**City of Biddeford
Staff Review Committee**

- 1.a 2024.11 Review and discuss a Site Plan Application for Five Star Holdings to expand their existing building at 451 Alfred Street, (Tax Map 17, Lot 17-2) in the 1-3 Zone.

SITE DEVELOPMENT PLANS FOR BOWLING-SCHORK section with project details and location information.

Re: Case # 2024.11 - Five Star Auto / Firestone – Building Addition / 451 Alfred Street / Tax Map 17 Lot 17-2 / Staff Review Committee (SRC) Meeting Comments of 6-24-2024

SHEET NUMBER: **C-201**

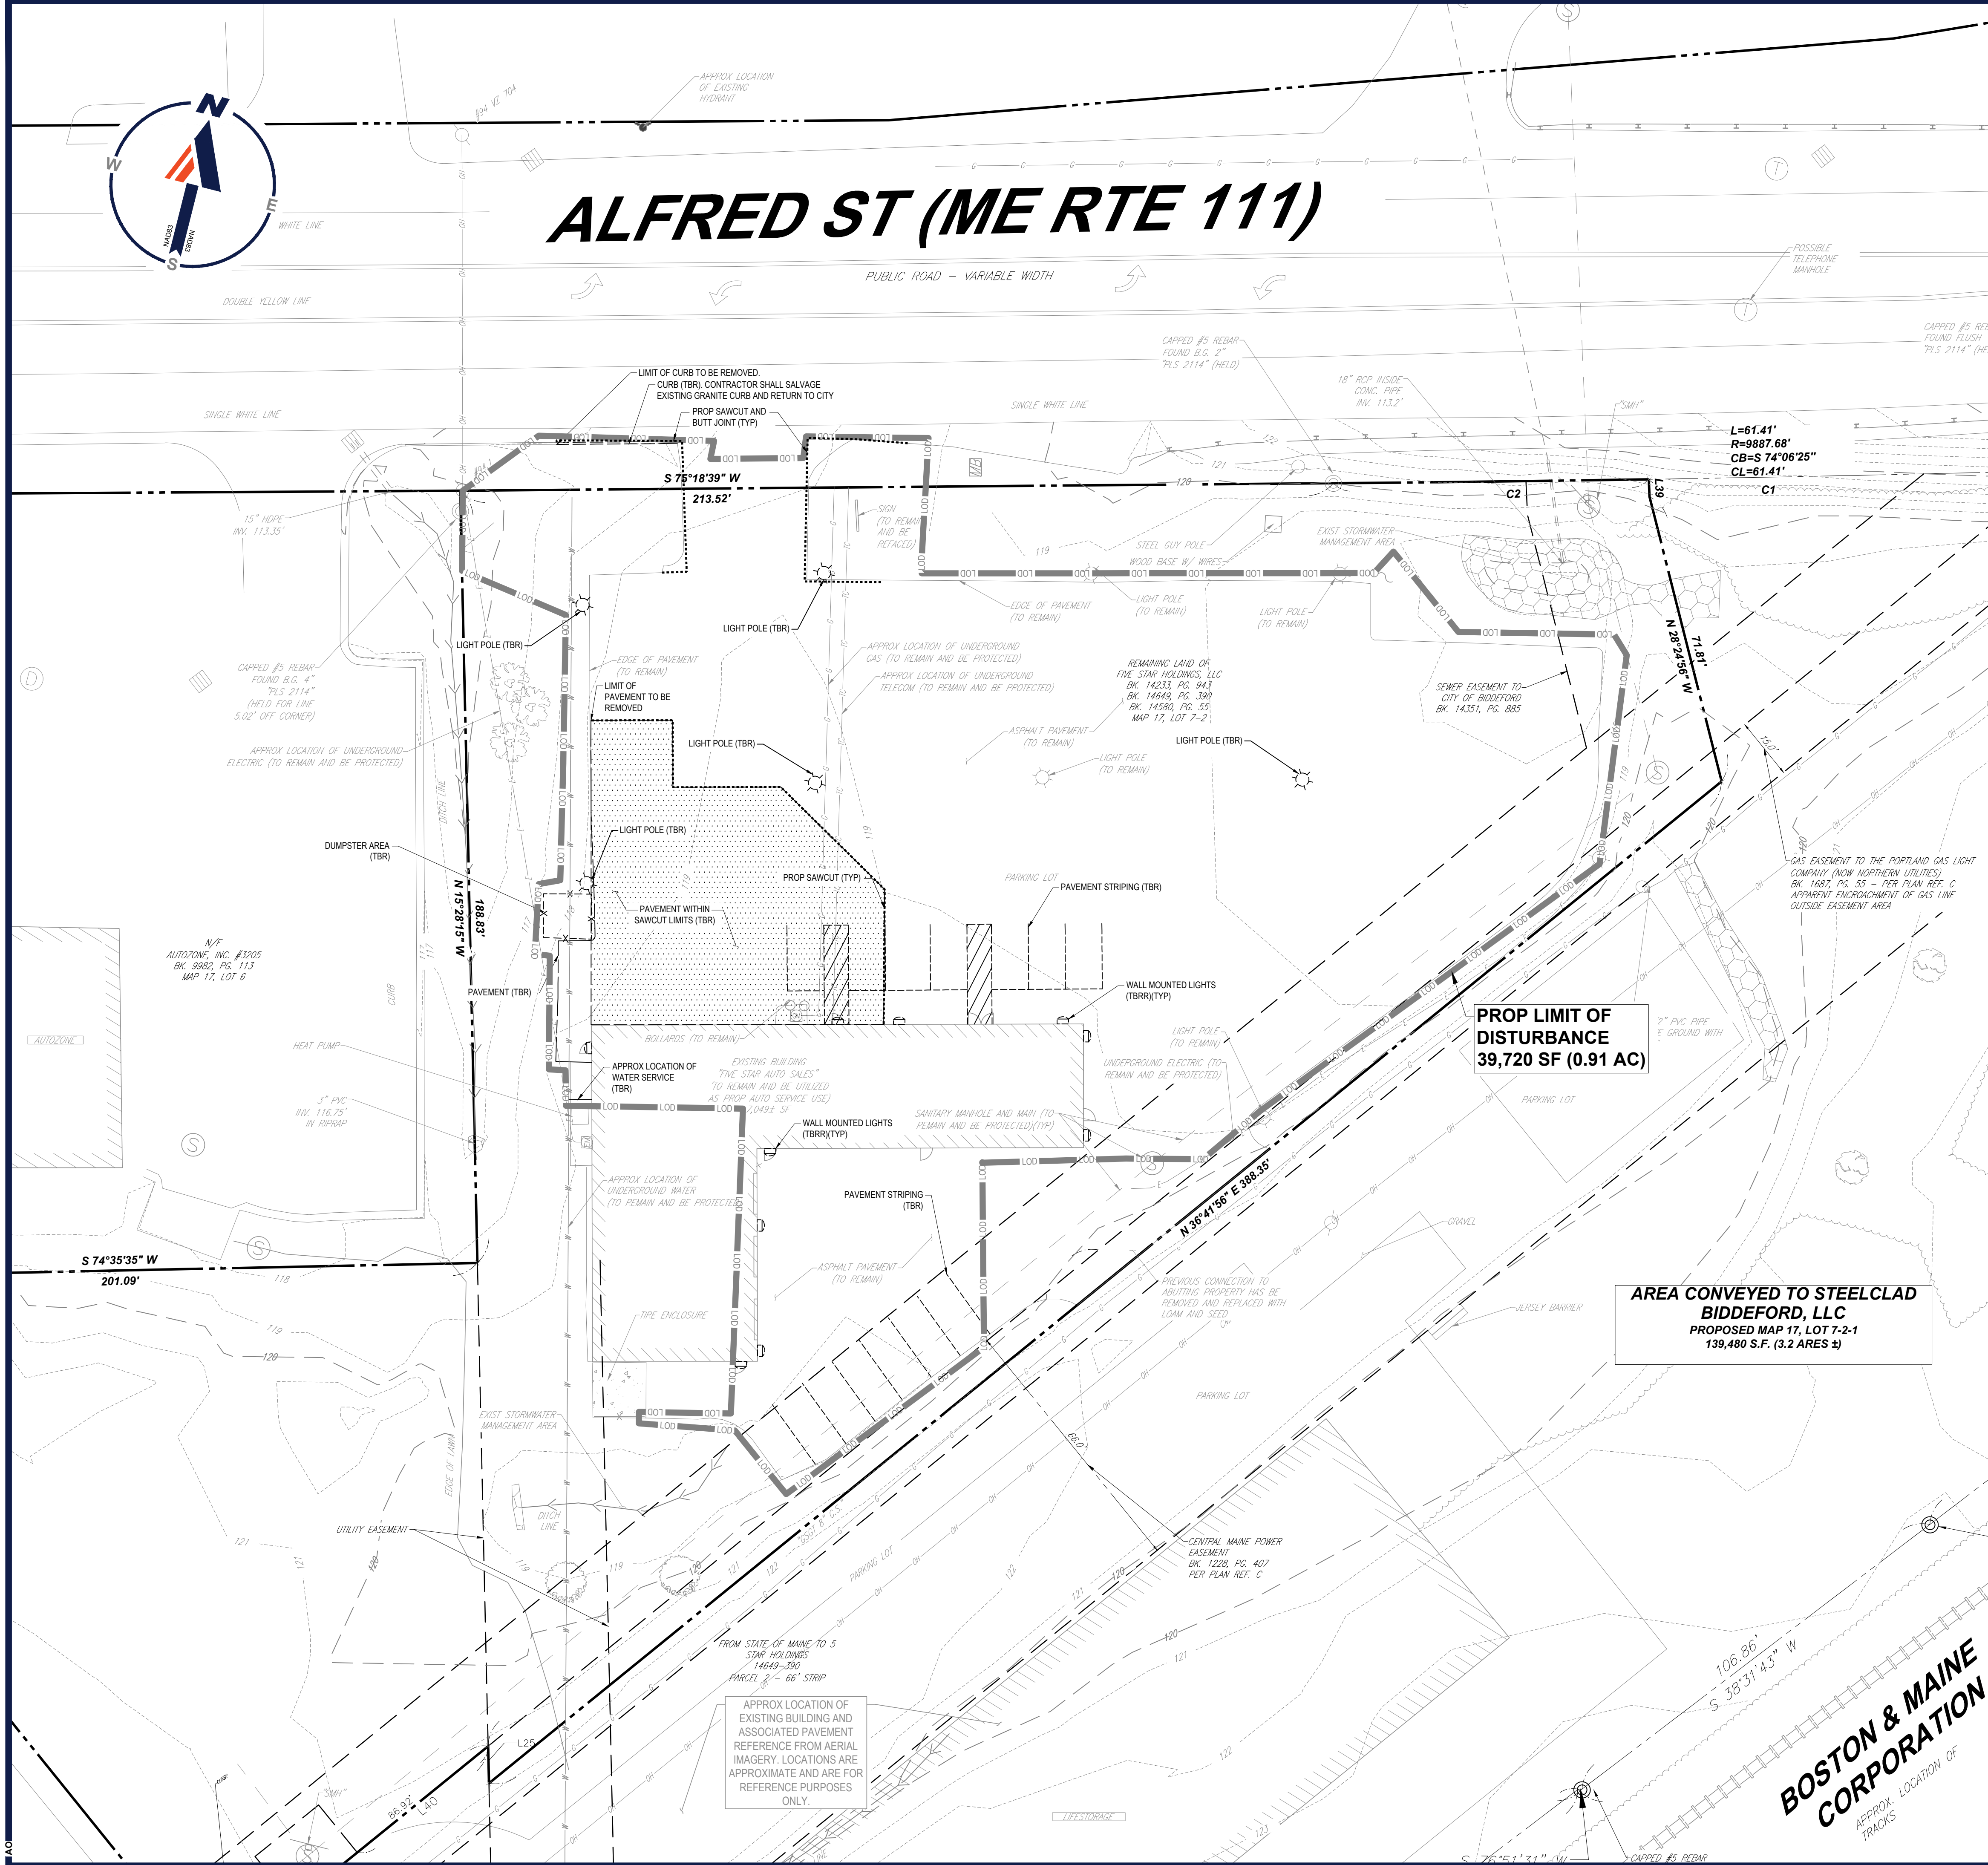
Comment #9 Interconnection Removal: The subject property previously provided a parking lot interconnect with the Steelclad self-storage property, located behind the existing structure which was removed as part of the Steelclad development. This shall be correctly illustrated on revised plans.

1. B. Drawings 1. Sheet C-201 – Existing Conditions and Demolition Plan

a. *The cover letter refers to existing stormwater management facilities on the site. These should be shown and called out on this plan.*

b. *Existing topography should be shown on this drawing.*

c. *Why does the limit of disturbance include the paved areas to remain?*

c. *The plan calls for the removal of Type 1 granite curbing in the right of way. Should this be salvaged for the city?*

Response: The previous interconnection between the project site and abutting property has already been removed. Loam and seed was added in the area of pavement removal. A note has been added to clarify this, please see sheet C-201 of the Proposed Site Development Plans.

Response: A label for each existing stormwater management area has been added to the Proposed Site Development Plans. Please see sheet C-201.

Response: Existing topography has been added to sheet C-201.

Response: The limit of disturbance surrounds areas where the existing pavement will remain, due to the proposed pavement striping that will take place. The limit of disturbance line is intended to encompass the limit of all work for the proposed project.

Response: A note has been added to sheet C-201, stating that the existing granite curb shall salvaged.

SHEET NUMBER:
C-401

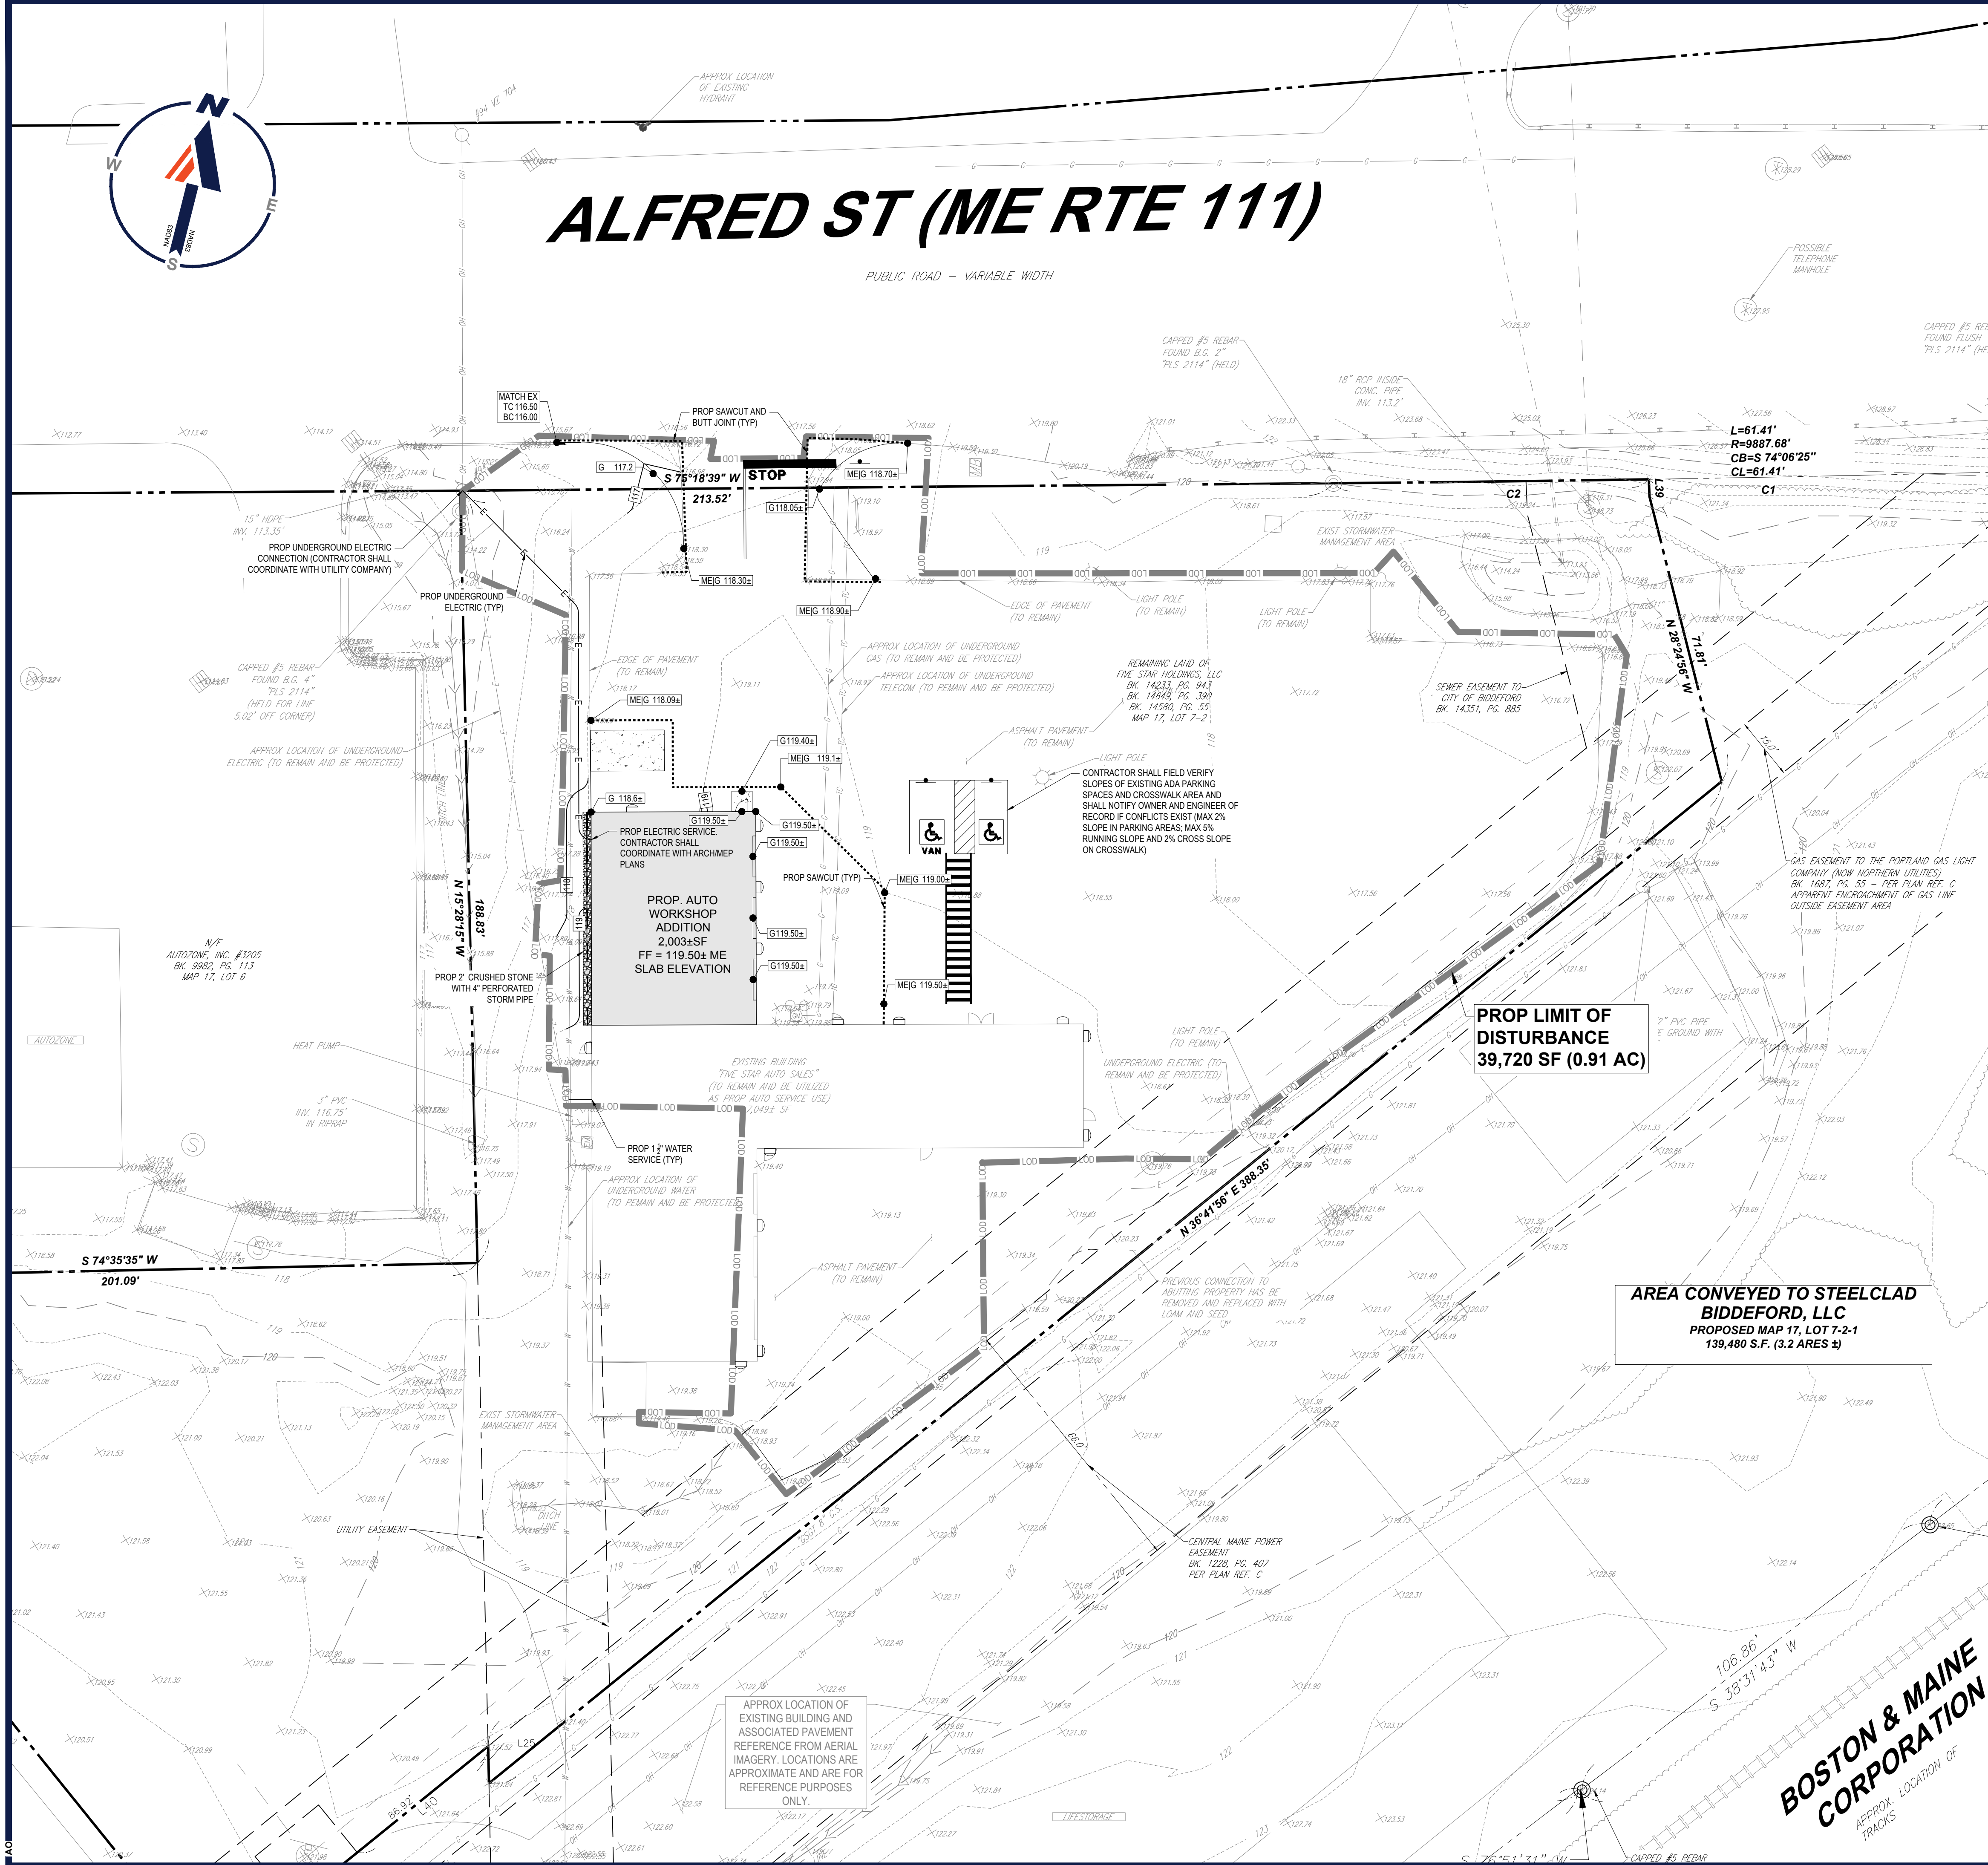
Comment #7 Contour lines: Revised plans shall include 2' contour lines.

Comment #8 Building Addition "drip edge": As discussed at the 6-26-24 SRC meeting, the stormwater run-off from the building addition shall be directed into the drainage ditch along the western property line. This may be done using a drip edge off the back of the addition which should then flow into the existing detention basin located at the southwest corner of the existing building.

3. Sheet C-401 – Grading Plan

a. *A note on the plan requires the contractor to verify the grades at the proposed accessible parking meet ADA requirements. It seems that should be verified by the engineer as part of the design. If the grades are too steep the parking may need to be relocated impacting the site plan.*

b. Will there be a drip edge or gutters on the westerly side of the addition?

Response: Existing contours are shown within the Proposed Site Development Plans, please see sheet C-401.

Response: A 2' crushed stone area, with a 4" perforated pipe has been added along the western side of the building expansion. Due to the existing contours on site, the water will naturally flow in the direction of the existing stormwater management area.

Response: Per the existing conditions survey, it appears that the existing grades along the proposed accessible path meets ADA requirements. The purpose of the note on the proposed plans is simply to have a contractor field verify this. As-builts can be provided in the ADA area to show compliancy after construction.

Response: Please see response to Comment #8.
